Visibility Splays for Existing and Proposed New Access Points for DC/23/2099
Creation of vehicular access onto B2135 and erection of farm gate

Supporting Documentation for Application DC/23/2099 Creation of vehicular access onto B2135 and erection of farm gate

Visibility Splays for Existing Point of Access

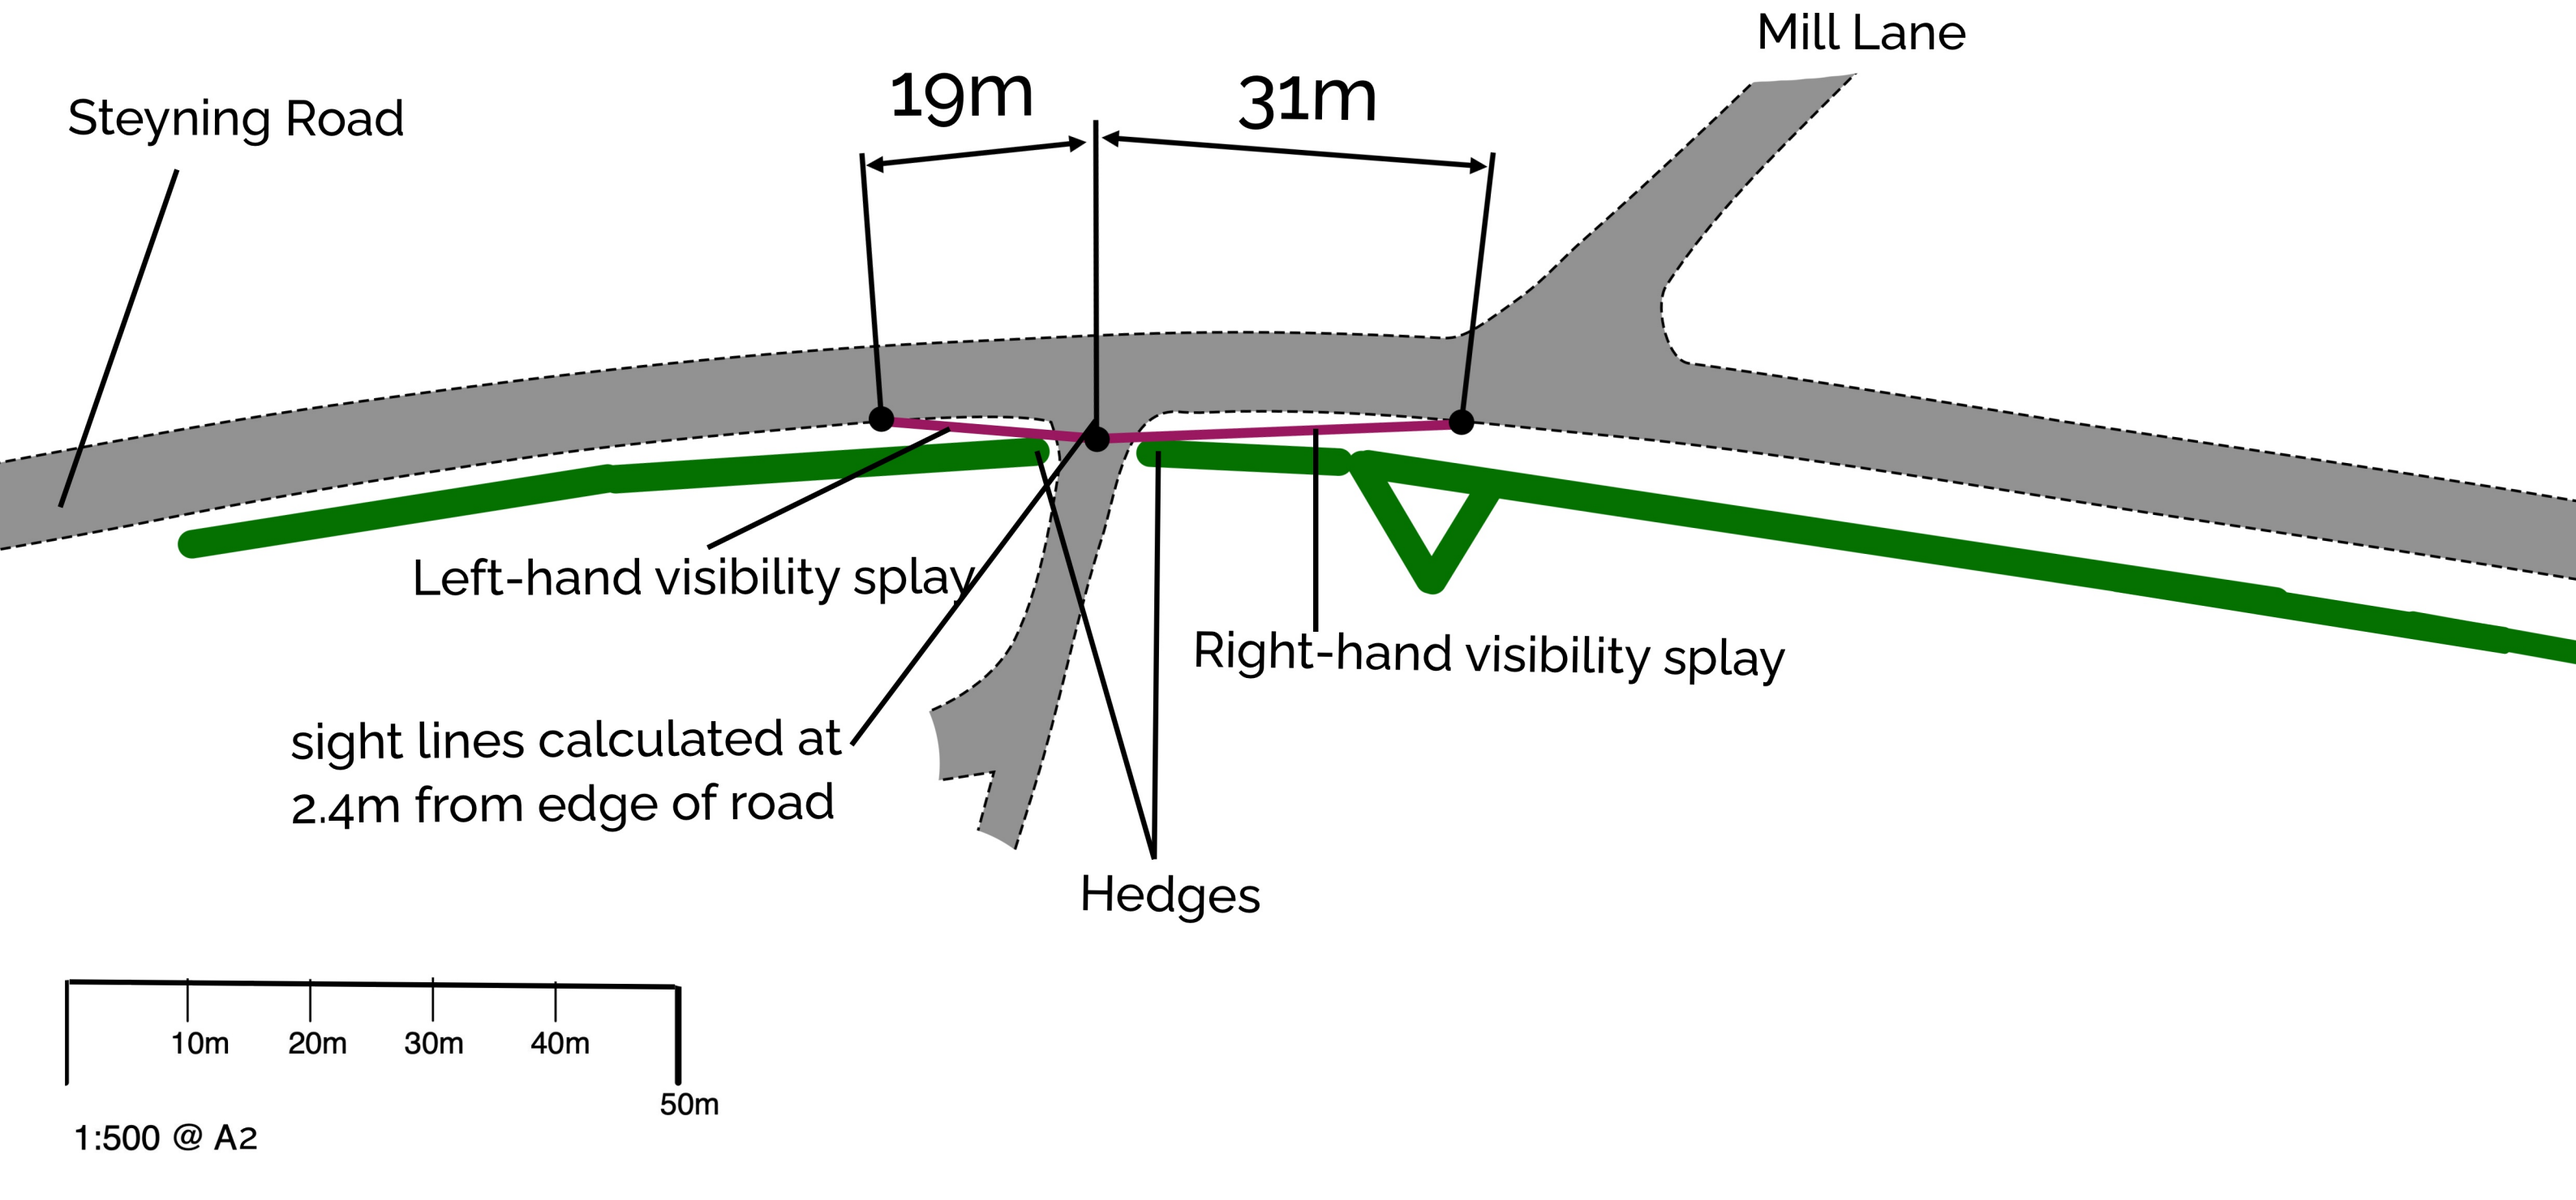
The consultation response explained that "*Should these splays not be wholly achievable, the applicant should demonstrate that the proposed access is an improvement over the existing access with regard to achievable visibility. This can be achieved by showing visibility from the existing access onto the highway compared with that of the proposed.*"

The only current access to the field from the public highway is across our property, from the shared driveway. This access is marked on the previously submitted location plan, within the red lines.

As can be seen from the visibility splays, the maximum achievable visibility from this driveway is very poor, owing to the entrance being on the inside of a bend in the road and with hedges on either side. The left hand visibility splay at 2.4m distance from the road is only 19m and the right hand visibility splay is only 31m.

Visibility Splays for Proposed New Point of Access

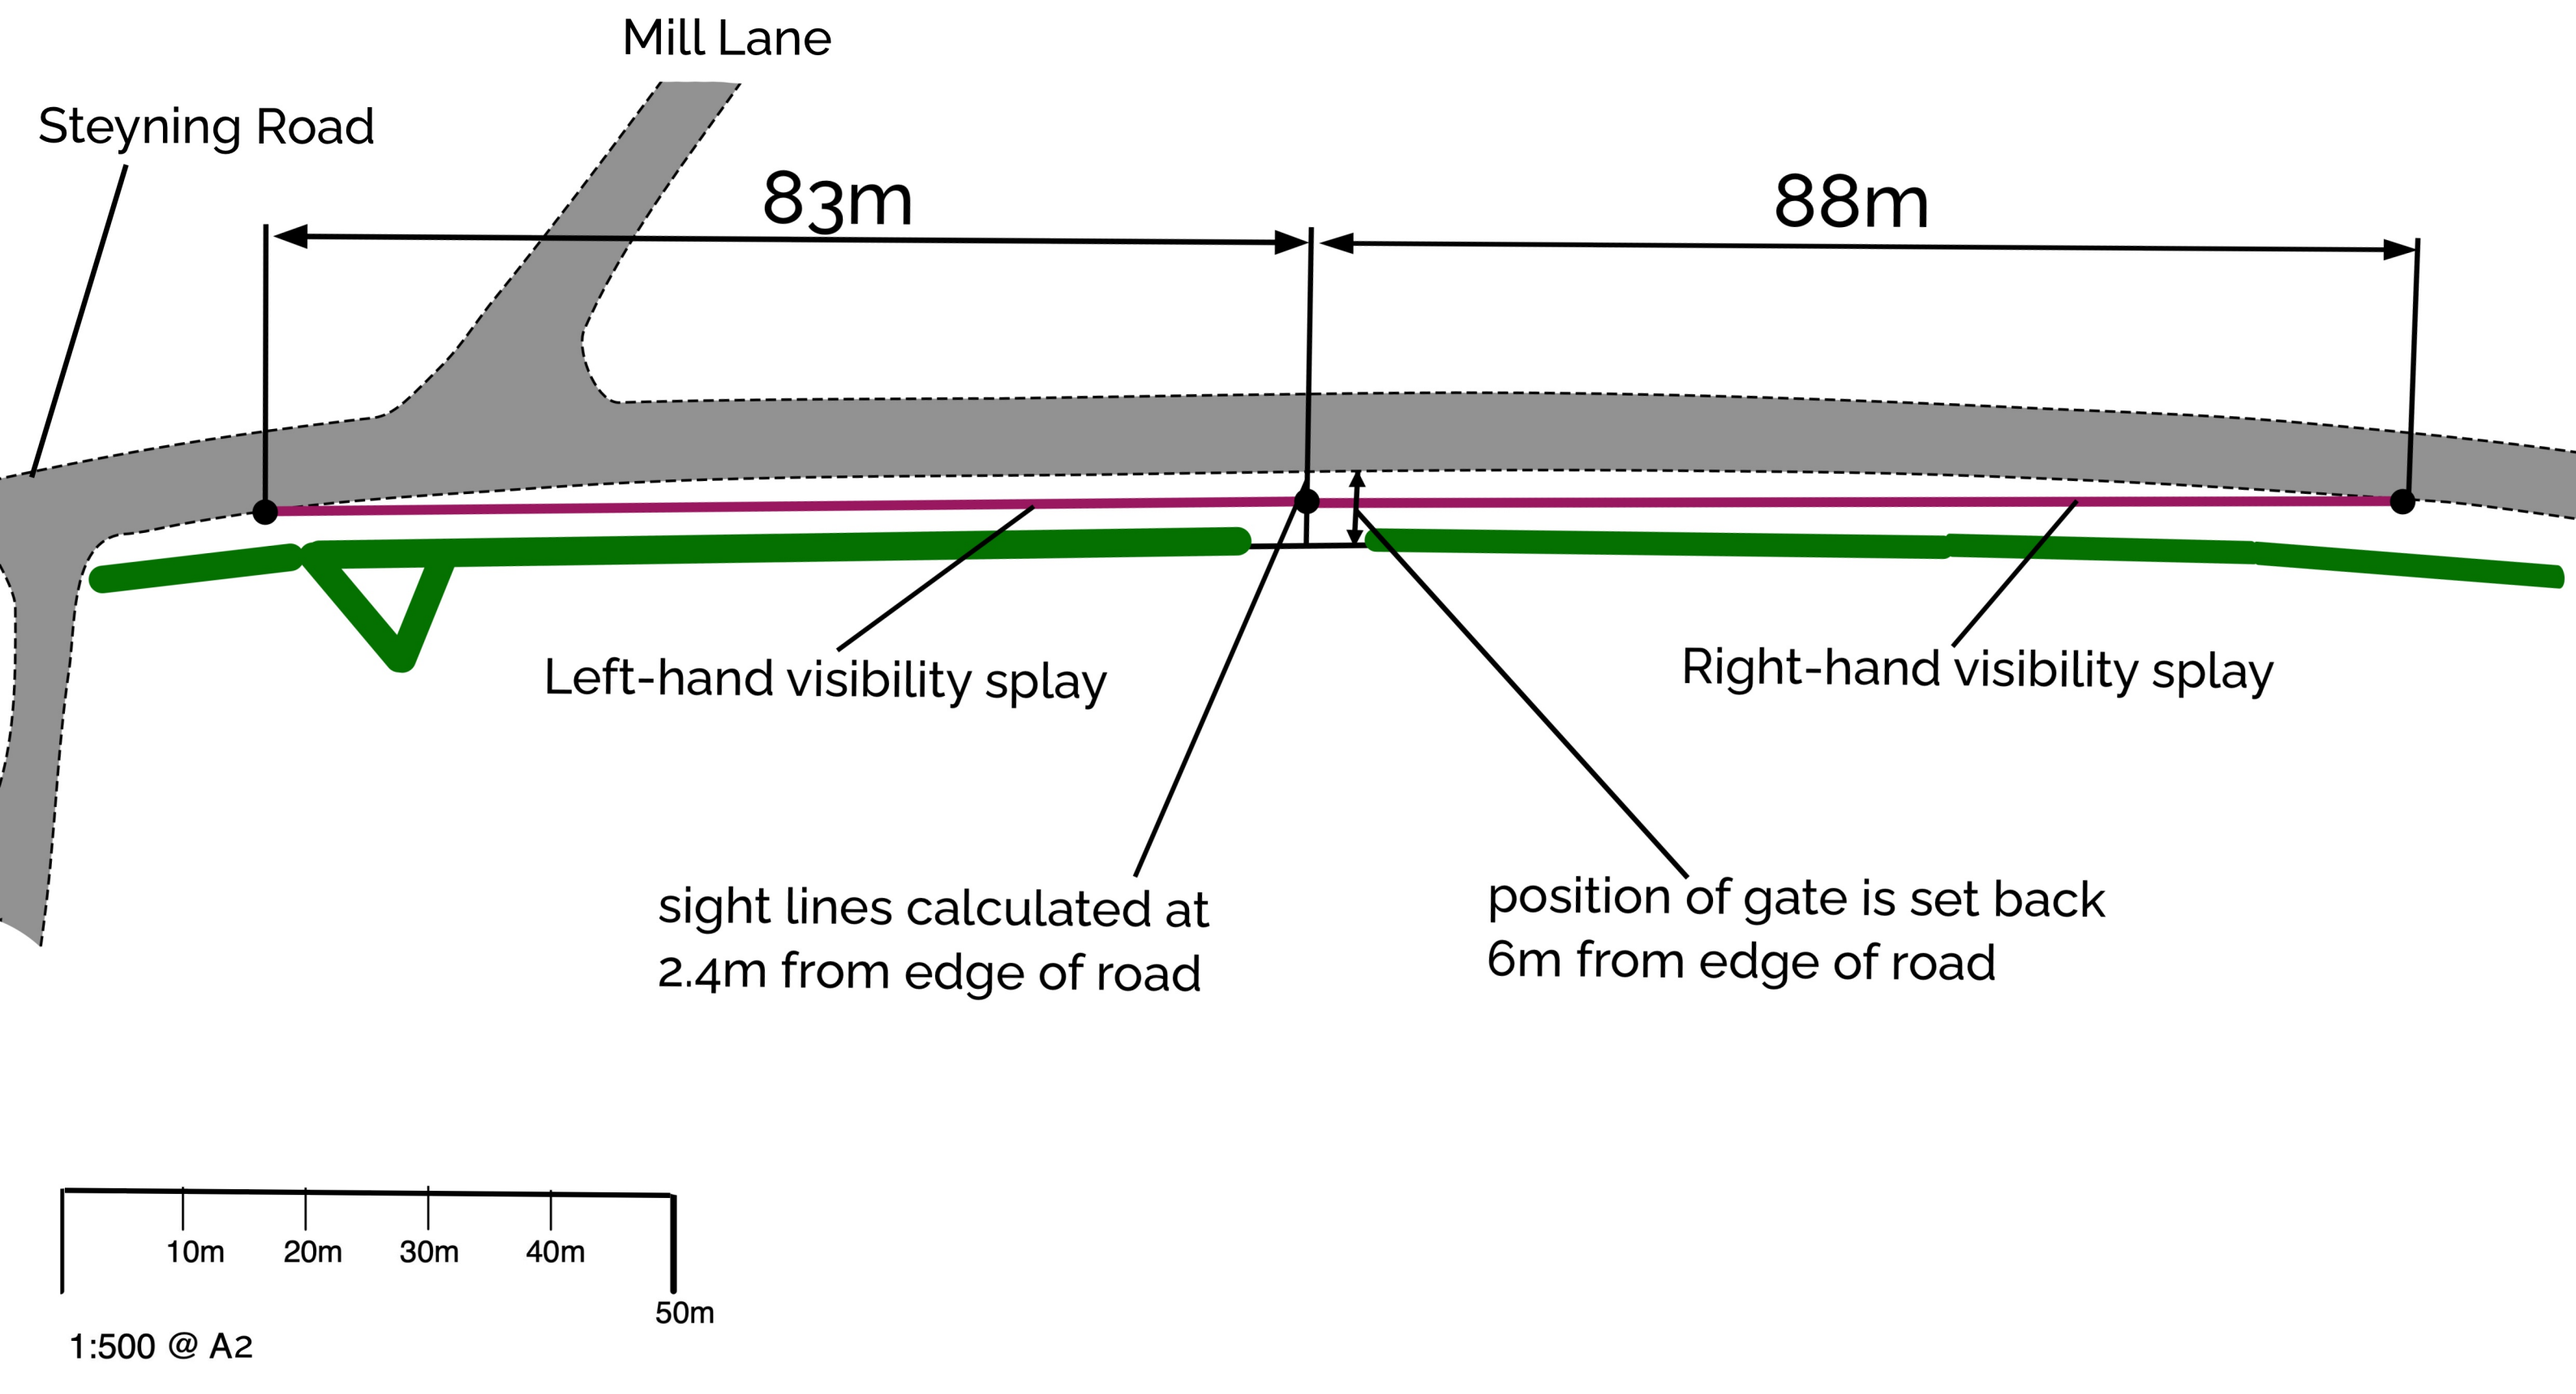
The *WSCC - Highways Authority* response to the consultation requested further information on achievable visibility from the proposed new point of access in line with national guidelines. In particular, they requested that visibility splays be provided.

As can be seen from the visibility splays, the maximum achievable visibility from this proposed new access point is far superior to the existing access. The left hand visibility splay at 2.4m distance from the road is 83m and the right hand visibility splay is 88m – in both cases significantly more than double the visibility splay from the current access.

The plan also has marked on it the location of the gate, which will be set back beyond the mid-point of the hedge to allow it to be a full 6m from the edge of the road, in line with the recommendation in the Highways Authority consultation.

While this represents a maximum achievable visibility that is less than the standards set out in Design Manual for Roads and Bridges (DMRB), it does represent a very significant improvement on the existing access.
